APPLICATION NO.	FILING DATE	FIRST NAMED INVENTOR	ATTORNEY DOCKET NO.	CONFIRMATION NO.
10/659,736	09/10/2003	Gary M. Richter	023720-0338	3906

Office Action Summary

This is the second office action for application number 10/659,736,
Merchandising System, filed on September 10, 2003.

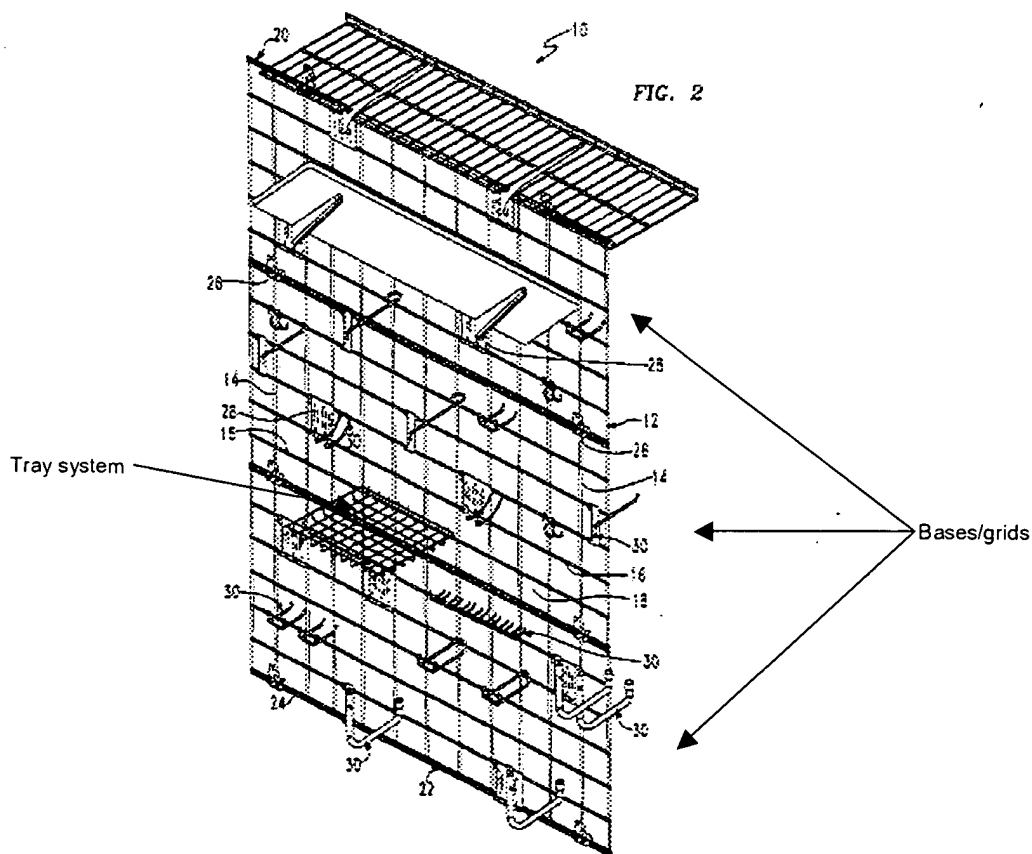
Claims 35-38, 40-43, 46, 47, 52, 54-56, 58, 59, 62, 64, 69, 70, 74, 76 and 77 are rejected under 35 U.S.C. 102(e) as being anticipated by U.S. Patent number 6,299,001 to Frovlov et al.

Frovlov et al. '001 discloses a system (above) comprising a plurality of bases/grids (above) each having a front and back and comprising separate horizontal rods (16), separate reinforcing members/supports/bars (24, above) coupled to the back of the base inherently providing rigidity to the base so that the base is inherently

resistant to deformation in more than one direction (column 3, lines 58-64), and brackets (above) coupled to the base, wherein the base further comprises separate vertical rods (14) coupled to the horizontal rods, wherein a front side of the vertical rods are welded to a side of the horizontal rods (column 3, lines 30-33), wherein similarly the vertical rods are welded to the backsides of the horizontal rods, wherein the brackets are coupled to the horizontal rods with at least one fastener (above) comprising a screw and plate (above), wherein the at least one fastener inherently allows space (above), wherein the bracket comprises hooks (above), wherein the vertical and horizontal rods are generally perpendicular to one another, wherein the reinforcement members provide support to the base, wherein the system further comprises a tray/tray system (above), wherein the vertical rods are spaced, wherein the vertical and horizontal rods are generally planar in configuration.

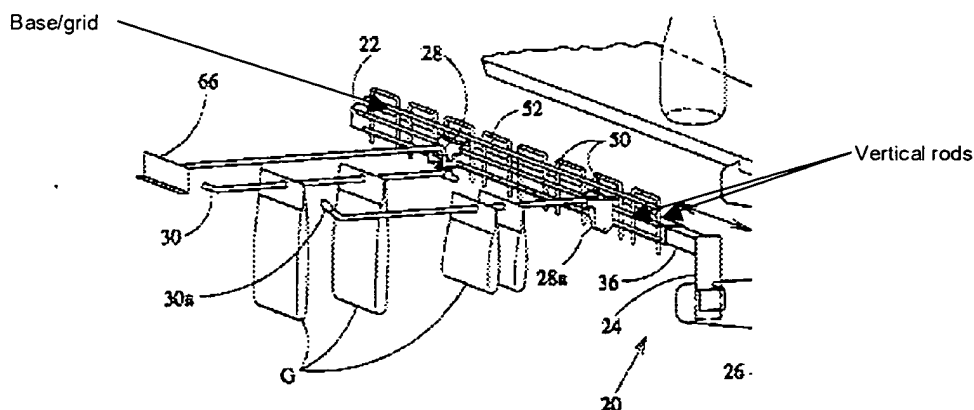
Regarding claims 39, 57 and 71, Frovlov et al. '001 teaches the previous invention wherein the horizontal and vertical members are *welded* together, wherein the reinforcement members/supports/bars are attached to the vertical members, but fails to specifically divulge the reinforcement members/supports/bars to be *welded* to the vertical members. It would have been obvious to one of ordinary skill in the art at the time the invention was made to have *welded* the reinforcement members/supports/bars

to the vertical members since it is already taught that doing so is a convenient and well known method of connecting two members together.

With respect to claims 48-51 and 65-68, Frolov et al. '001 teaches the previous invention failing to specifically teach the vertical members to have a diameter of about 0.30 to 0.425 inches and more specifically a diameter of about 0.375 inches, or the horizontal members to have a diameter of about 0.285 to 0.35 inches and more specifically a diameter of about 0.306 to about 0.312 inches. It would have been obvious to one of ordinary skill in the art at the time the invention was made to have constructed the diameters of the vertical and horizontal members of any number of various dimensions, including those as previously recited, because doing so is considered a design choice and hence not considered patentable since the applicant has not specifically recited in the originally filed specification why such a dimension is critical to the invention or produces any unexpected result. See *In re Kuhle*, 526 F.2d 553, 188, USPQ 7 (CCPA 1975).

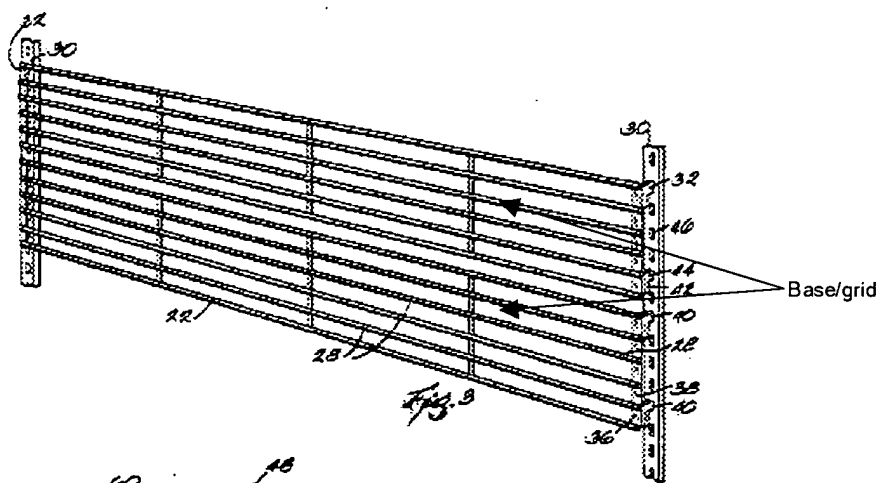
Claims 35, 36, 44, 60 and 72 are rejected under 35 U.S.C. 103(a) as being unpatentable over U.S. Patent number 6,471,079 to Berlingieri.

Berlingieri '079 teaches a system (figure 1) comprising a base/grid (above) having a front and back and comprising separate horizontal rods (52), a separate member/support/bar (22,36) coupled to the back of the base inherently providing rigidity to the base so that the base is inherently resistant to deformation in more than one direction, and brackets (28,28a) coupled to the base, wherein the base further comprises separate vertical rods (above) coupled to the horizontal rods, wherein the vertical rods are welded to the backsides of the horizontal rods (column 6, lines 10-12), wherein the member/support/bar is a square tube. However, Berlingieri '079 fails to specifically teach more than one member/support/bar. It would have been obvious to one of ordinary skill in the art at the time the invention was made to have provided more than one member/support/bar since doing so would be seen as simply a duplication of parts. See *In re Harza*, 274 F.2d 669, 124 USPQ 378 (CCPA 1960).
